AMENDMENTS TO THE DRAWINGS:

REMARKS

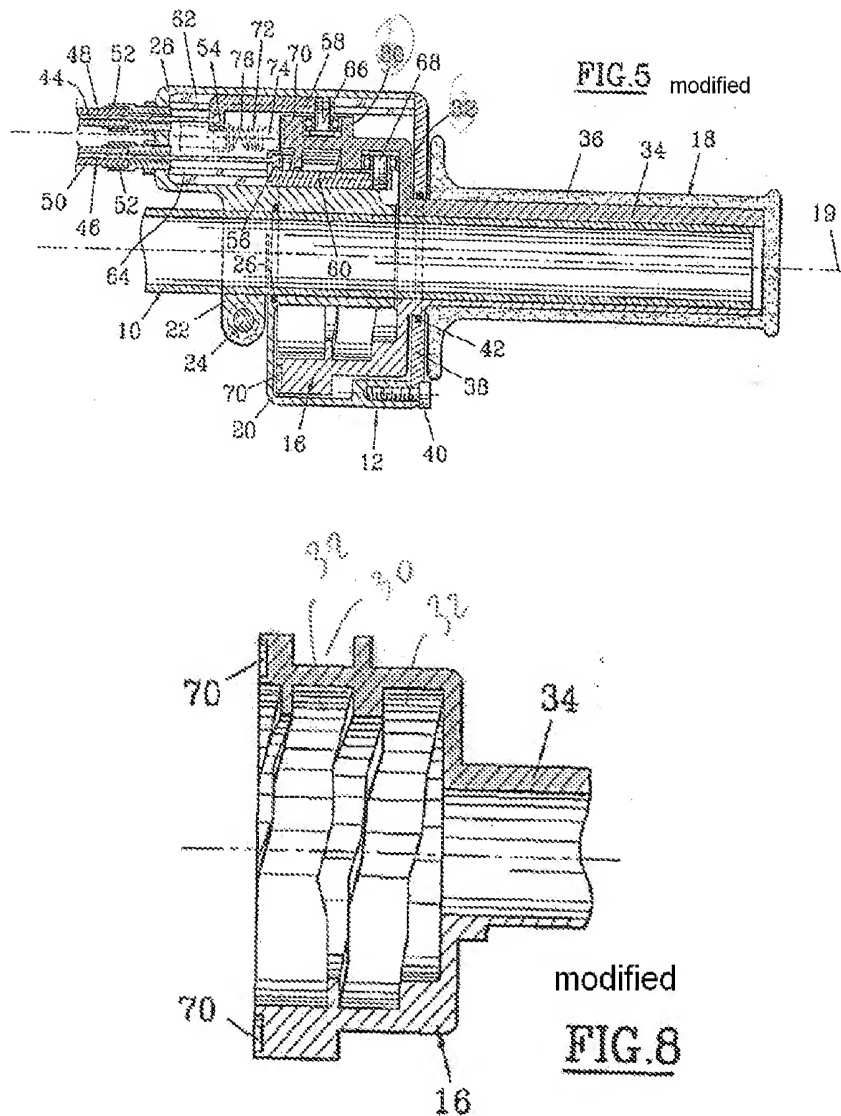
If one were to equate the speed changer of SAVARD with the recited speed changer, this would require that one of the two tracks 30 and 32 of SAVARD moves with the handle independently of the other track (are rotationally coupled intermittently).

However, this is not the case because handle 18 and tracks 30, 32 are integral as described and shown in the drawings (see C. 9, ¶. 41-45 and fig 5 or fig 8, a modified version provided below with the tracks and handle represented in color).

Thus, both tracks and the grip of SAVARD are always rotationally coupled. SAVARD does not suggest that a second operating mechanism and a rotating grip are rotationally coupled intermittently to the first operating mechanism as required by claim 1. Accordingly, SAVARD does not anticipate claim 1 and the claims that depend therefrom.
